Addendum

Town of Brookfield

Request for Design Engineering Qualifications

June 28, 2024

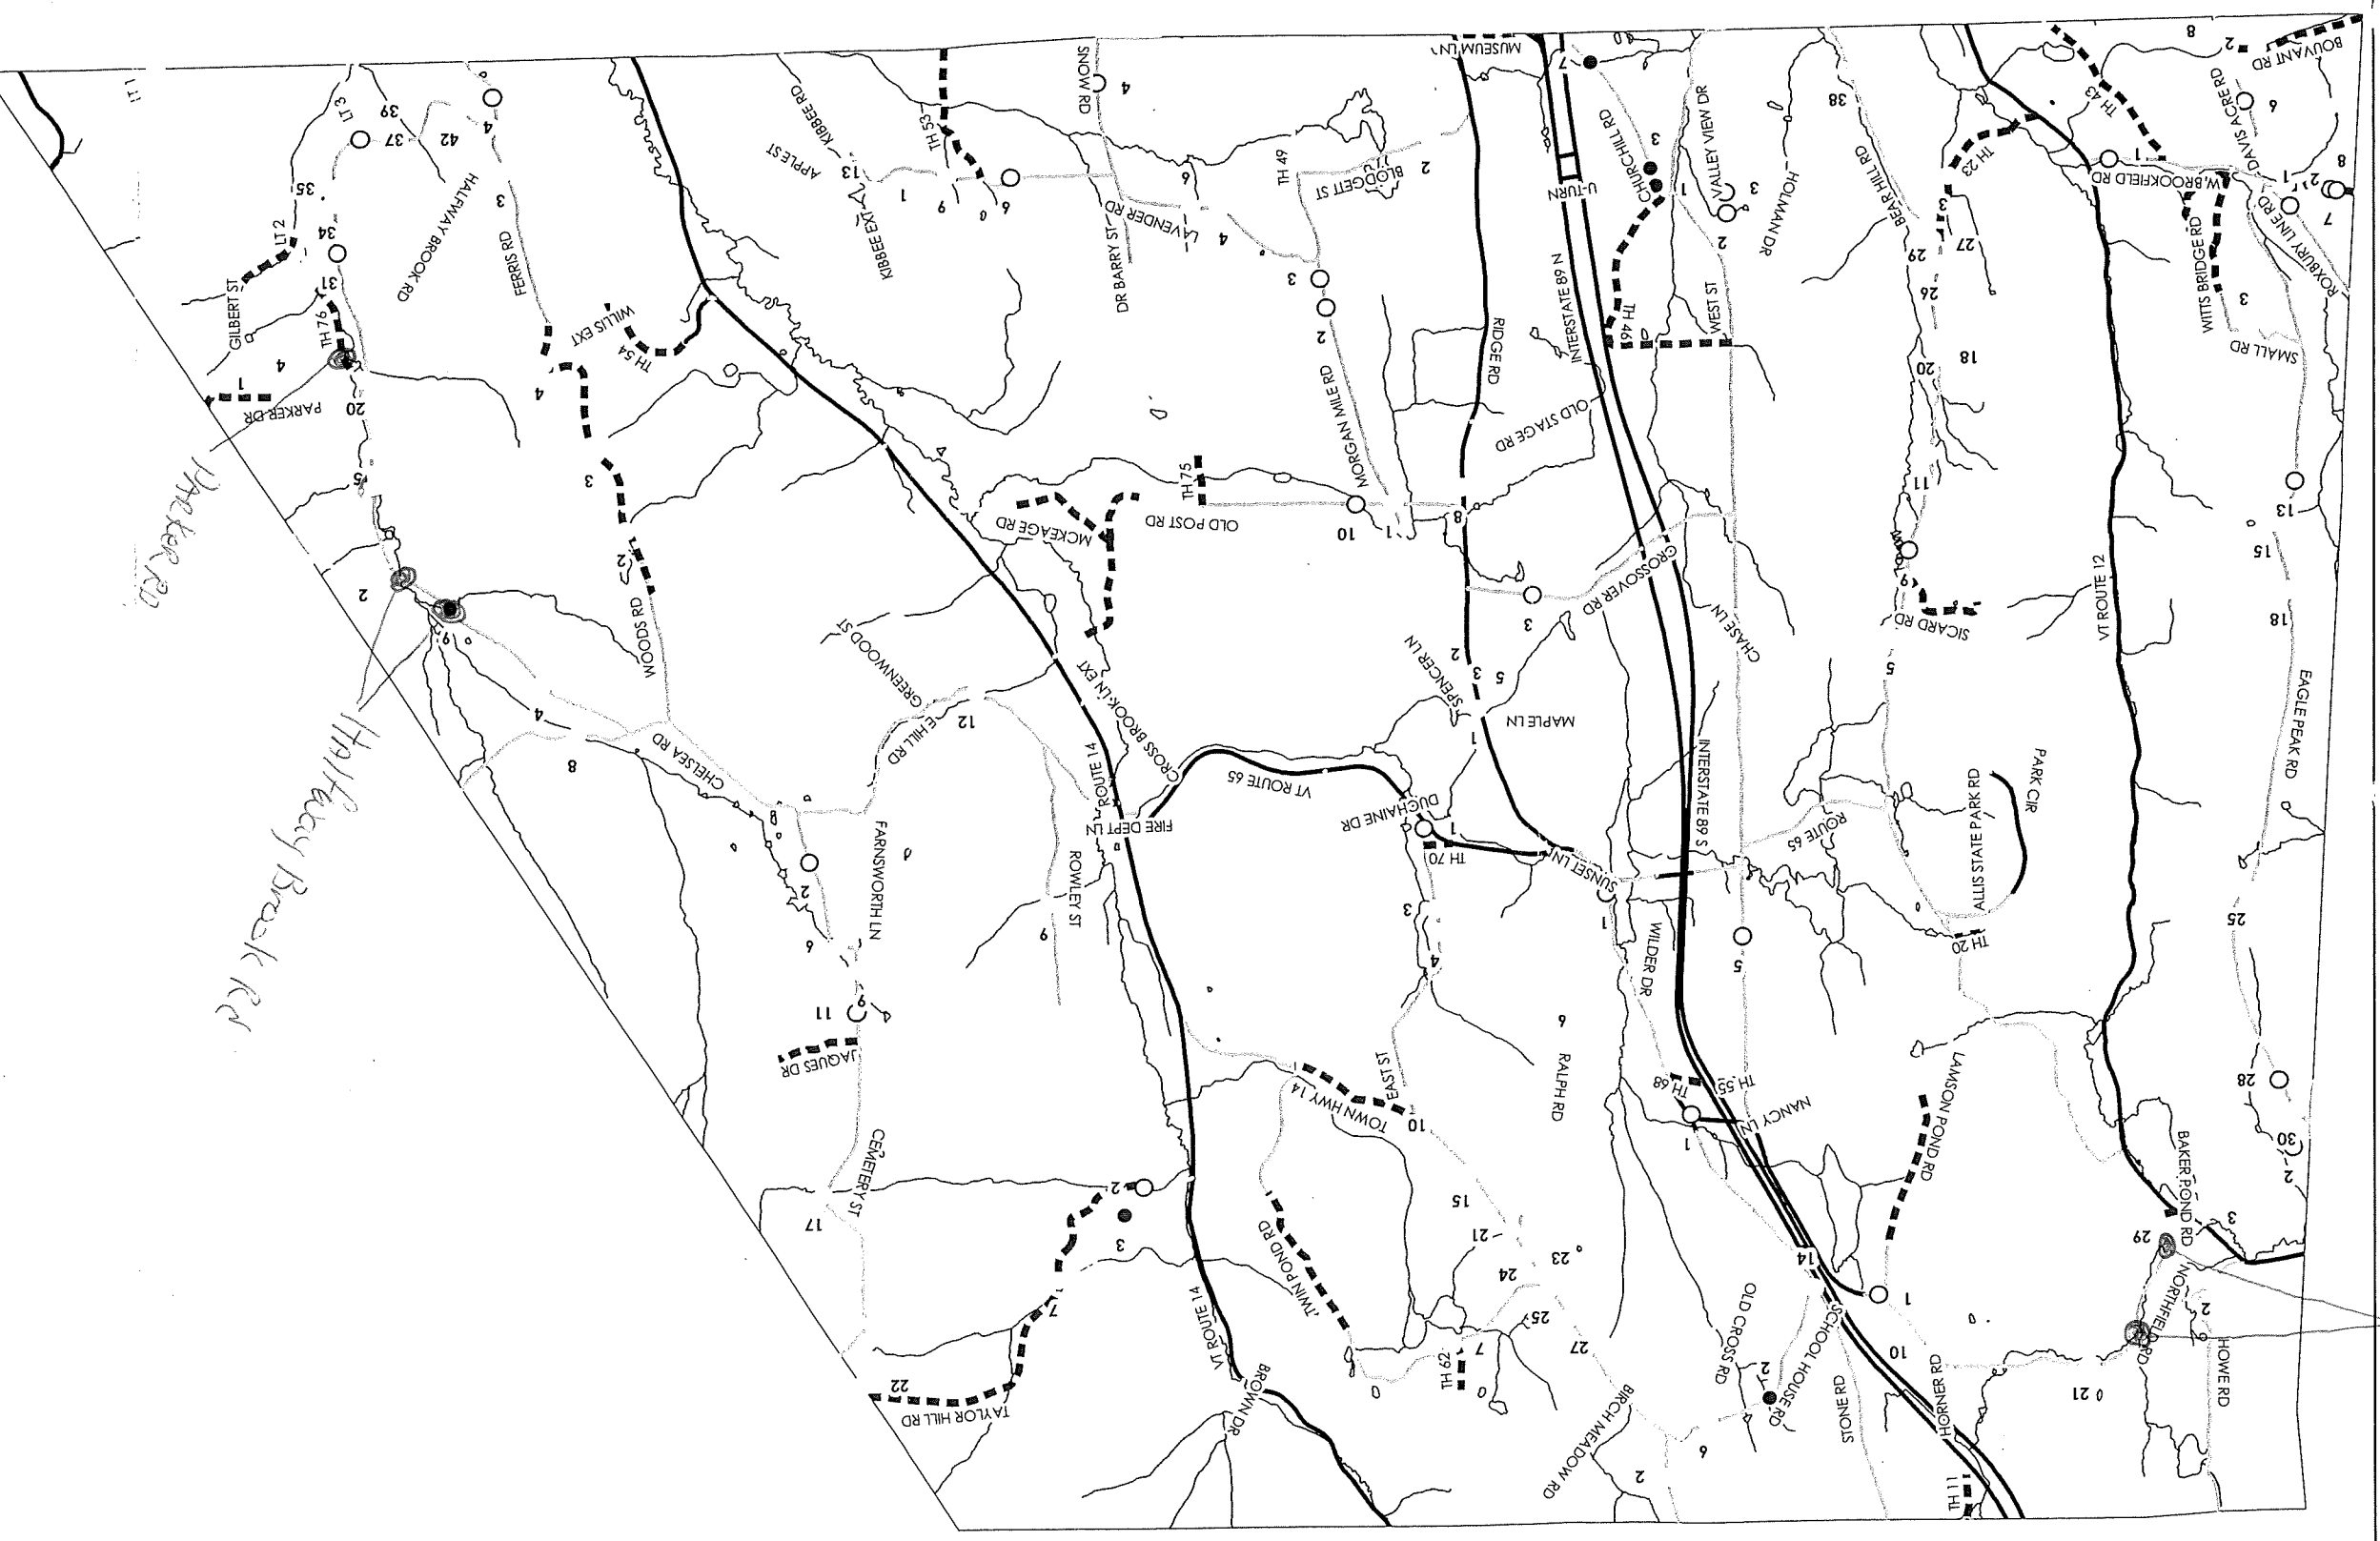
1. Q. Can you please provide a location map?  
R. The VTrans H&H reports contain the coordinates for the structures, however as noted in the RFQ, two of the reports are still pending, therefore a location map is herein provided.
2. Q. Are the Federal Funds administered by VTrans?  
R. Yes, all FEMA funds are process through the State.
3. Q. Can you confirm that permits can be obtained after the fact?  
S. Permits required for construction must be obtained during the design process and included as a part of the Bid/Construction Documents.
4. Q. Does VTrans ROW process apply?  
R. The three roads involved all have a three rod Right-of-Way. The Town will assist in obtaining any additional permanent or temporary easements if required
5. The Town has received one of the two requested H&H studies for the structures on Northfield Road which is attached.

*Handwritten notes:*  
Ducker Rd  
Hoffmeyer Brook Rd

*Handwritten note:*  
Northfield Rd
